Project: DOUGLAS STATION
LSMO
Issue Date: August 11, 2023

COVER SHEET
Construction Plans for:
Douglas Station Commercial Park
Lee's Summit, Jackson County, Missouri

REVISIONS
REV. 3/7/2024

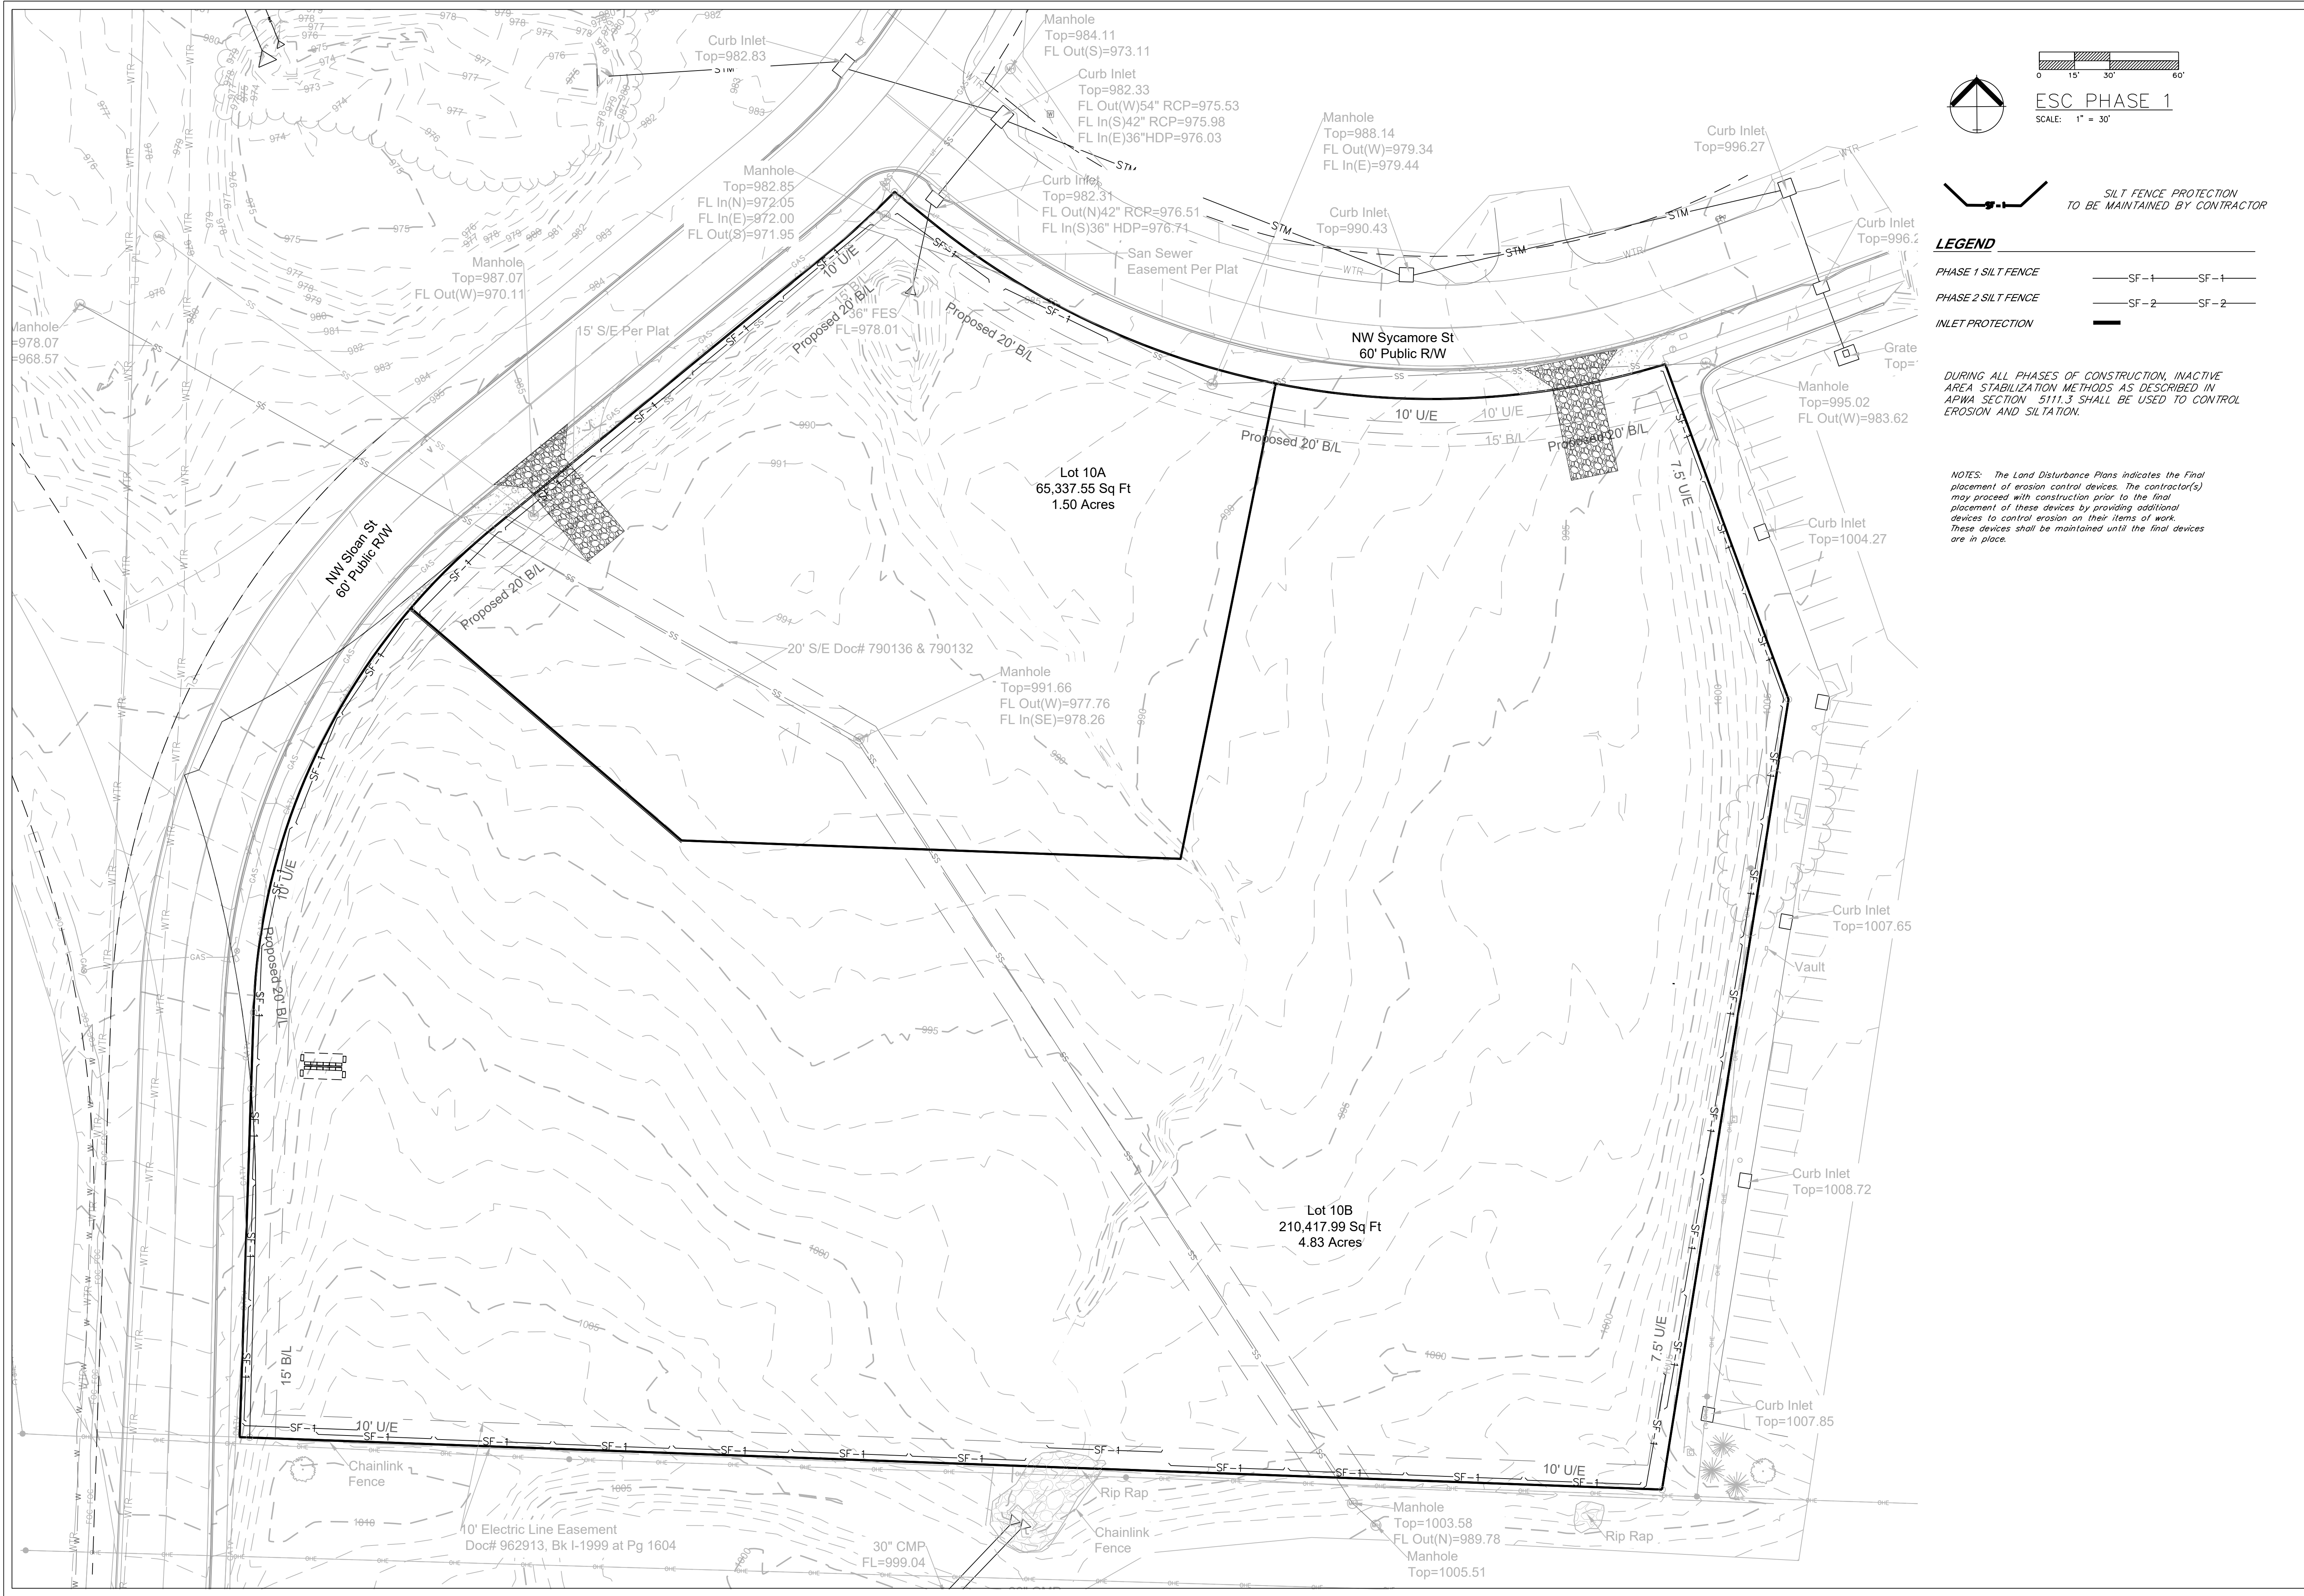
Revised Site Improvement Notes.

ADDED SUMMARY OF QUANTITIES

Sanitary Sewer Improvements
~The site will utilized the existing sanitary sewer on the east side of NW Sloan St and south side of NE Sycamore St.

Water Main Improvements
~The site will utilized the existing water on the west side of NW Sloan St and north side of NE Sycamore St.

Storm Sewer
~Enclosed pipe systems and inlets will be collected and convey the onsite storm water runoff and direct it toward the existing public storm sewer system.

Storm Water Detention
~The site will utilize the existing regional detention facility

Summary of Quantities:

HANDICAP SIGN DETAIL

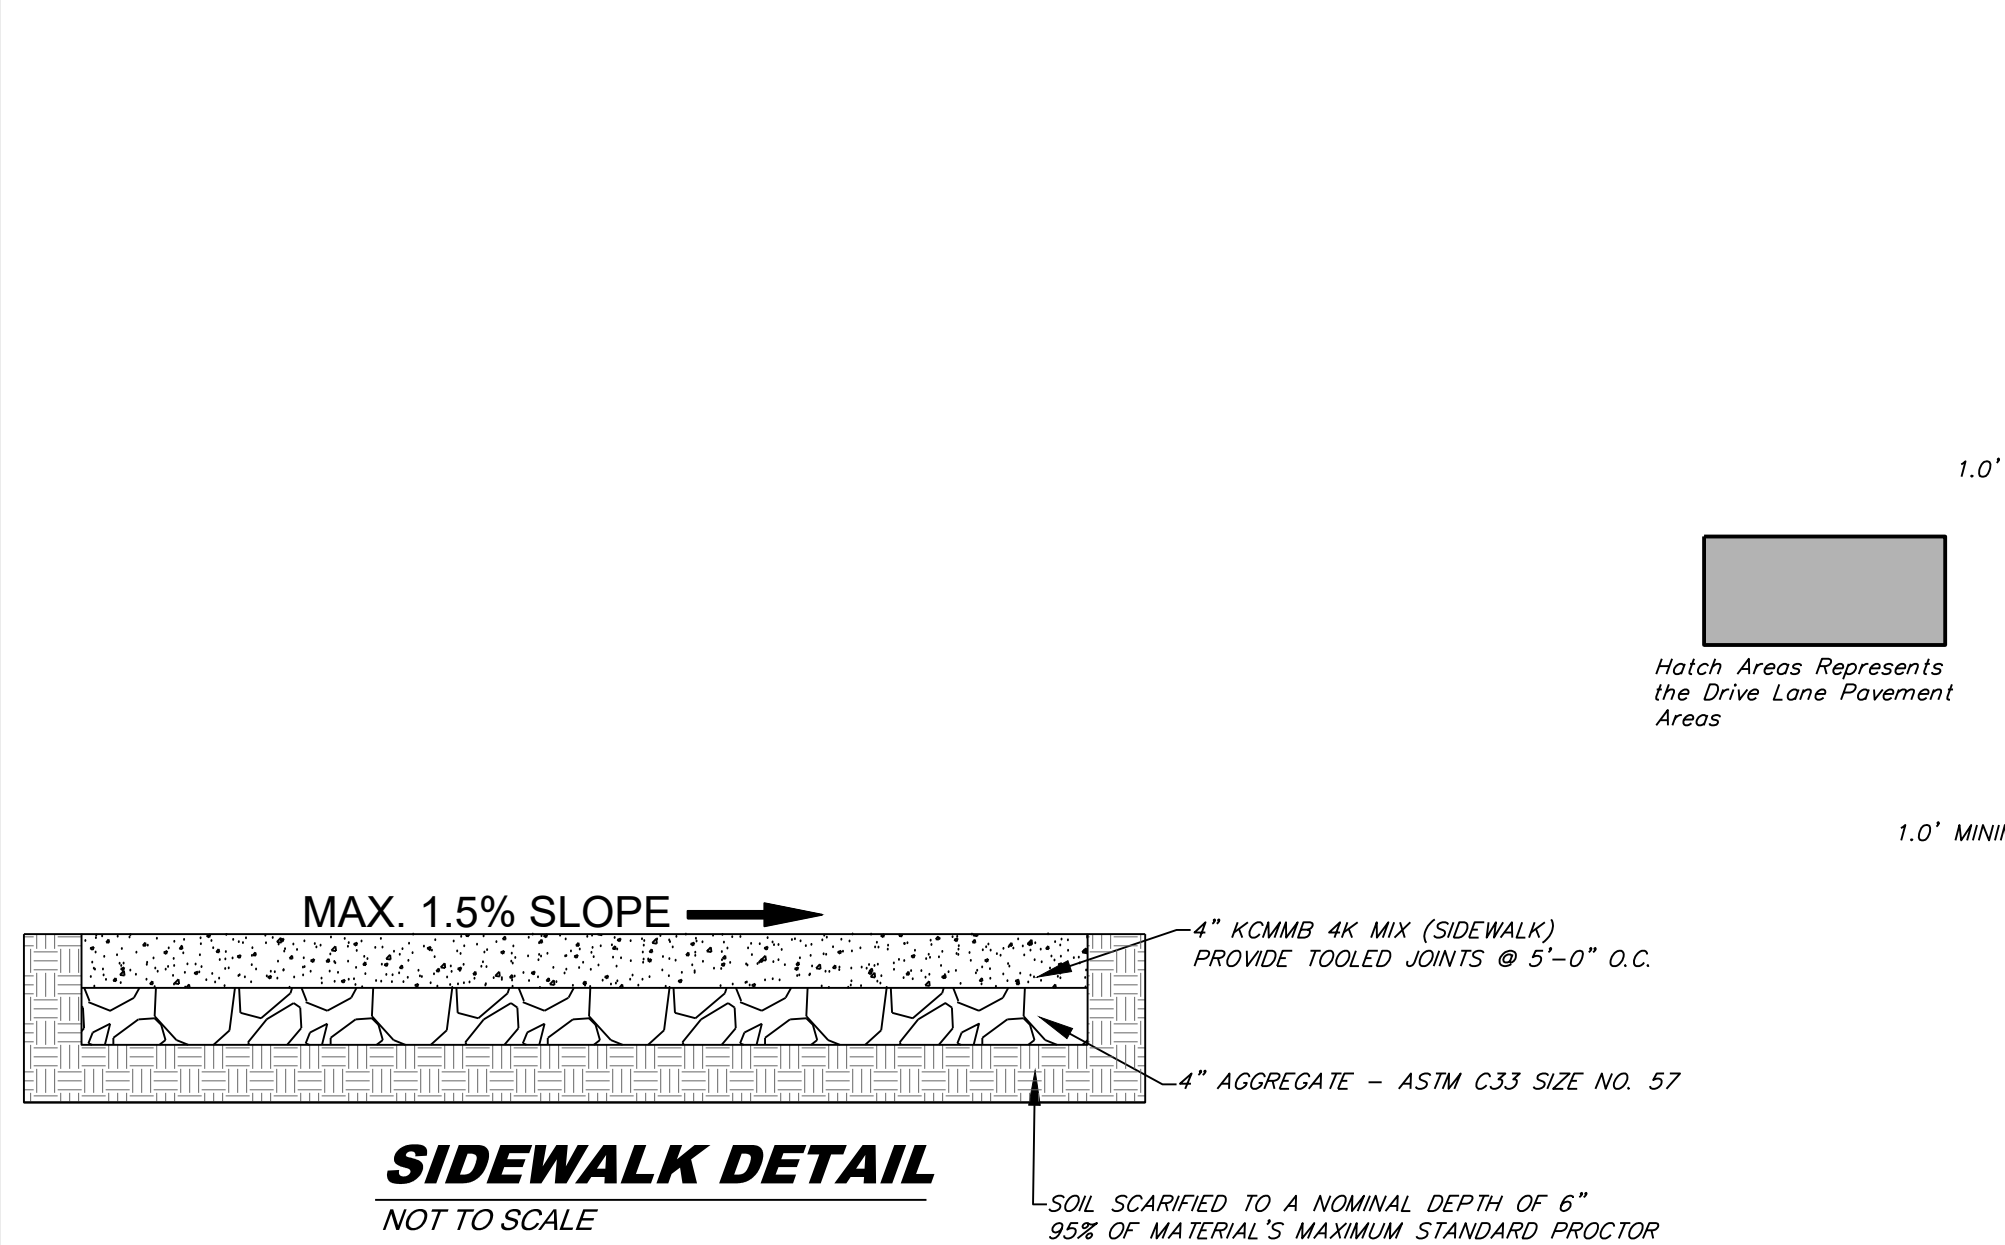
1 ADDED ADA SIGN DETAIL.

Dimension Plan

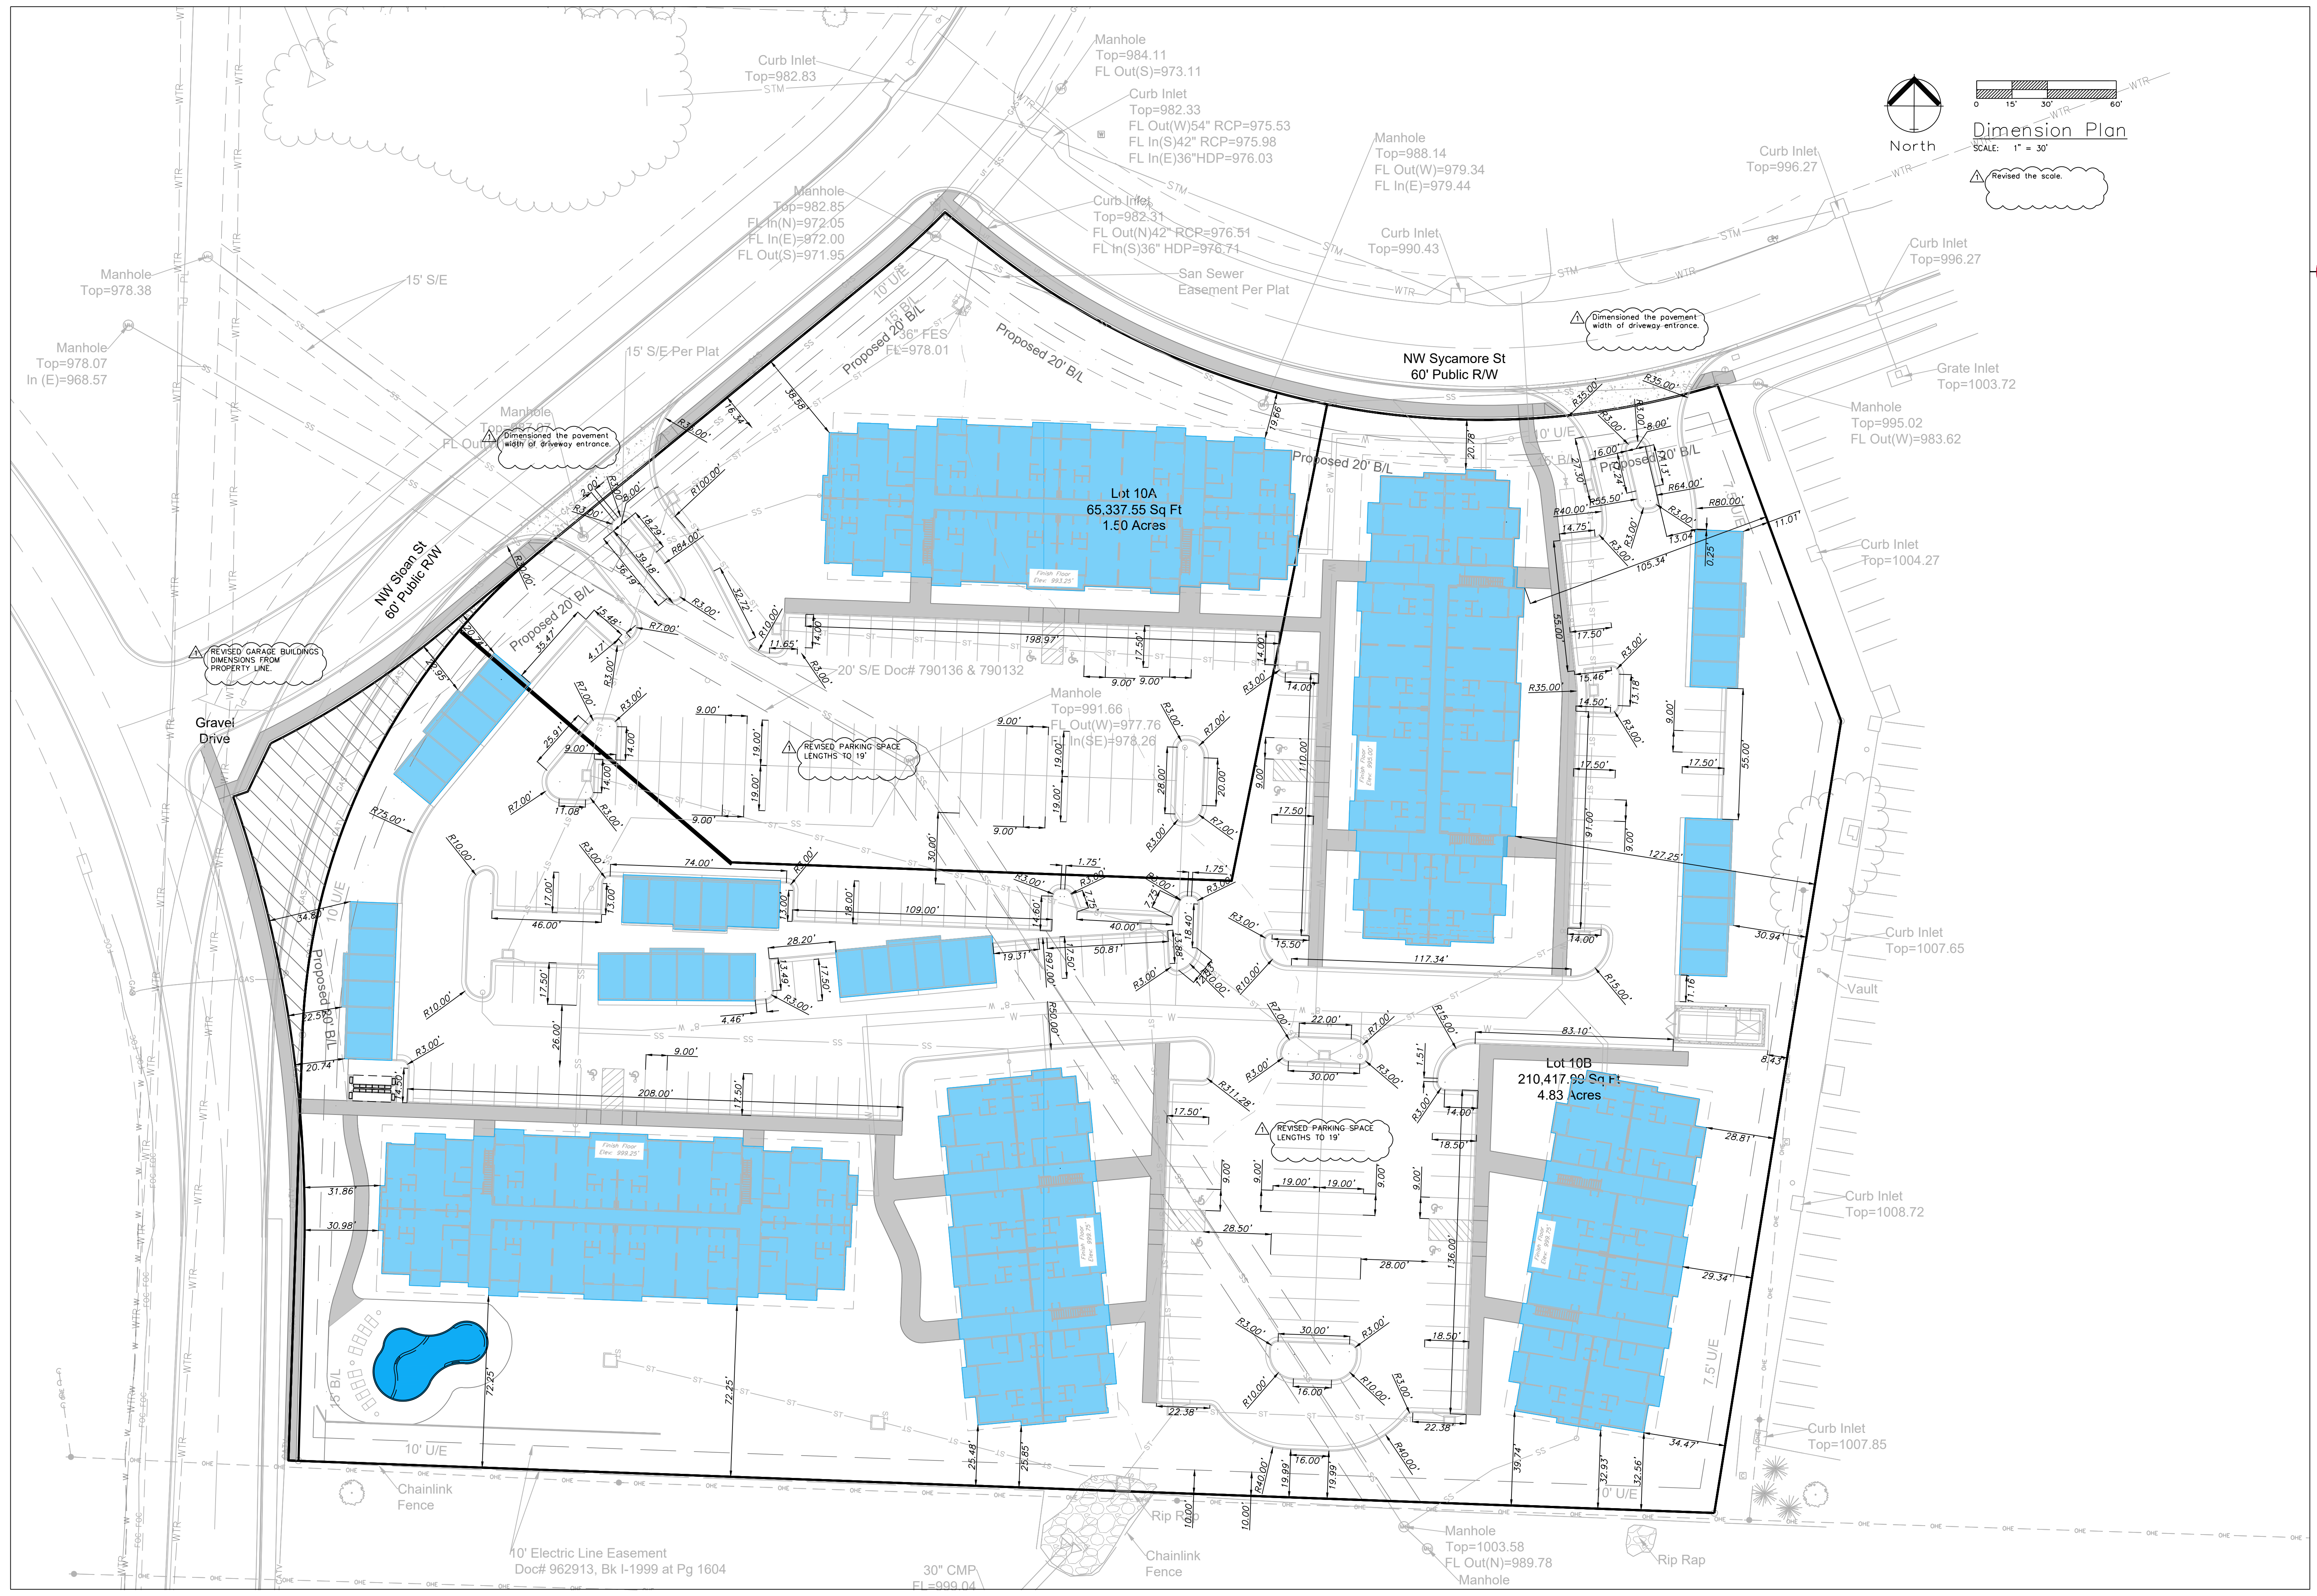
Revised the scale

SCALE: 1" = 30'
